BROWN & ROOT, INC. CPSES JOB 35-1195	PROCEDURE NUMBER	REVISION	EFFECTIVE DATE	PAGE
	CCP-30	10	1/26/82	1 of 13
TITLE: COATING STEEL SUB-STRATES INSIDE REACTOR BUILDING AND RADIATION AREAS	ORIGINATOR:	<u>Mark L. Bellis</u>		<u>1-23-82</u> DATE
	REVIEWED BY:	<u>[Signature]</u> B&R QA		<u>1-23-82</u> DATE
		<u>[Signature]</u> TUGCO QA		<u>1-23-82</u> DATE
	APPROVED BY	<u>Charles Weiss</u> CONSTRUCTION PROJECT MANAGER		<u>1-24-82</u> DATE

JOB 35-1195
Comanche Peak Steam Electric Station

Construction Procedure
DOCUMENT CHANGE NOTICE NUMBER 7

BROWN & ROOT, INC. CPSES JOB 35-1195	PROCEDURE NUMBER	REVISION	EFFECTIVE DATE	PAGE
	CCP-30A	2	9/20/82	1 of 13
TITLE: COATING STEEL SUBSTRATES INSIDE REACTOR BUILDING & RADIATION AREAS	ORIGINATOR:	<i>Mark Miller</i>	<i>9/17/82</i>	DATE
	REVIEWED BY:	<i>[Signature]</i> B&R QA <i>[Signature]</i> AUGCO QA	<i>9/16/82</i>	DATE
	APPROVED BY	<i>[Signature]</i> CONSTRUCTION PROJECT MANAGER	<i>9-17-82</i>	DATE

Attachment 3
CZ-11 CURE TO TOPCOAT TIME
25-50% R. H.

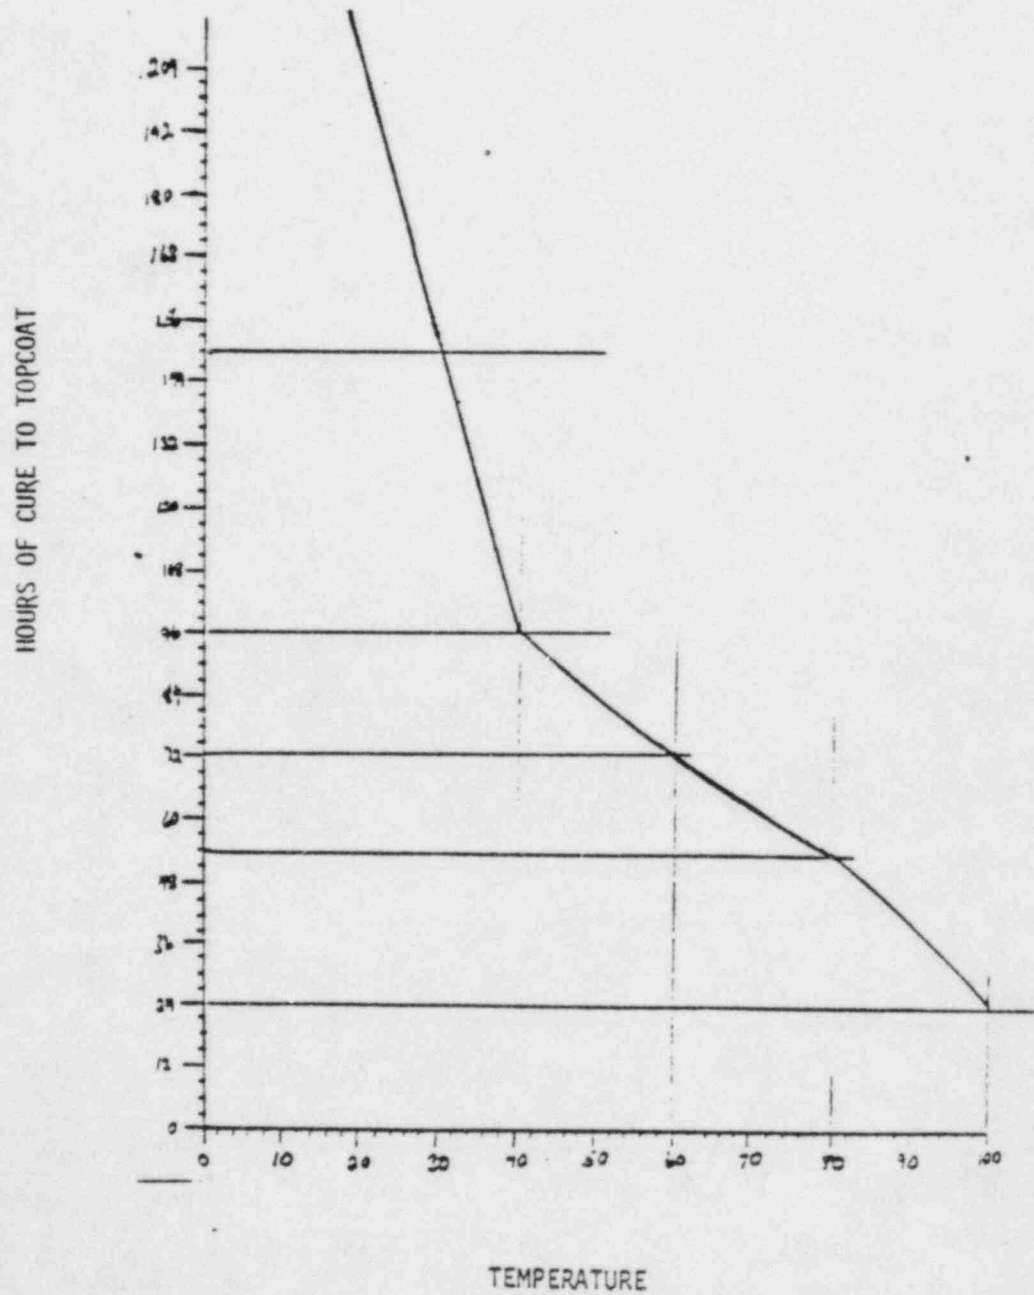
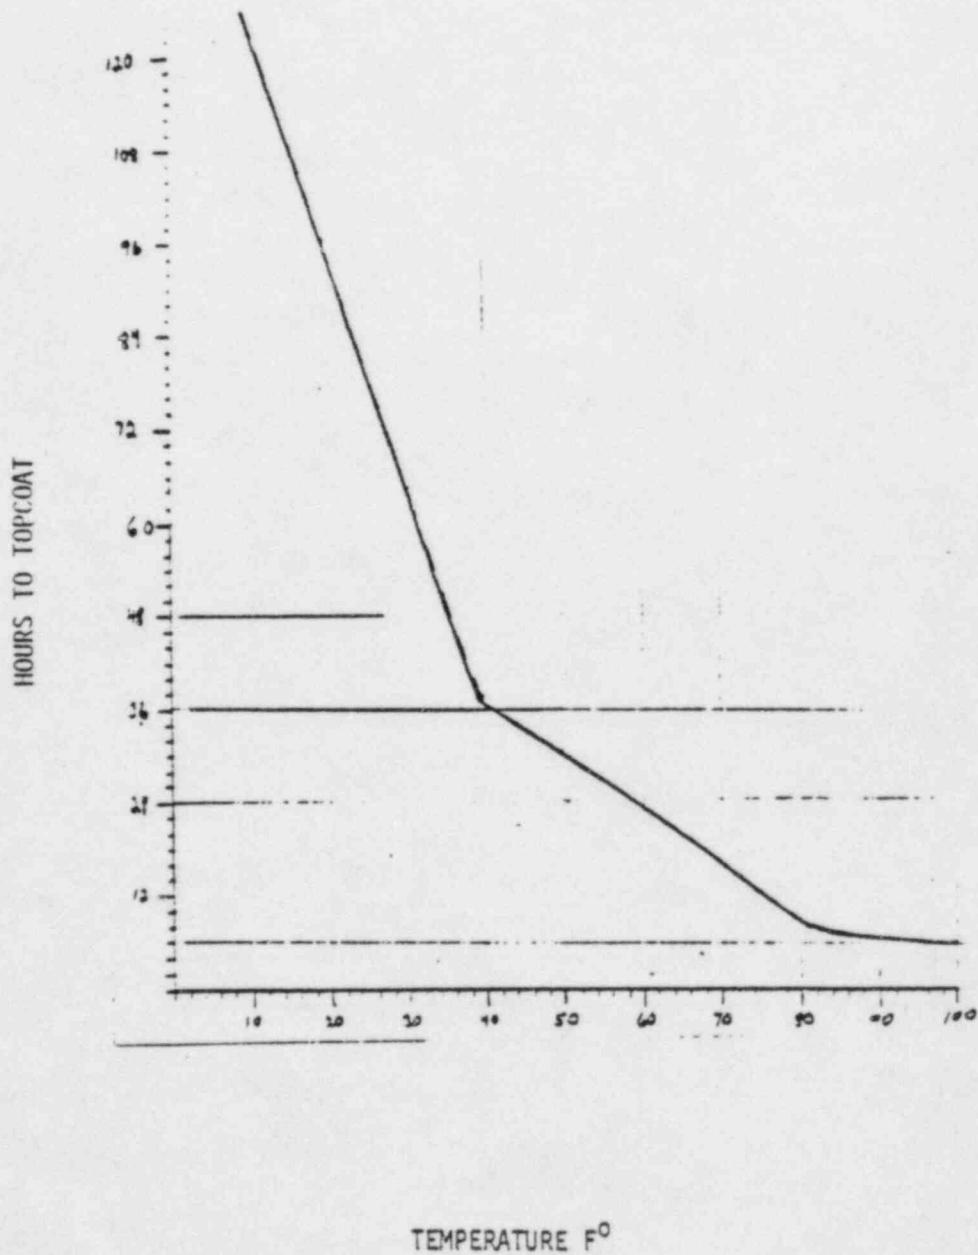
Page 8 of 13
Attachment 3 Page 1 of 2
Attachment 3 Page 2 of 2
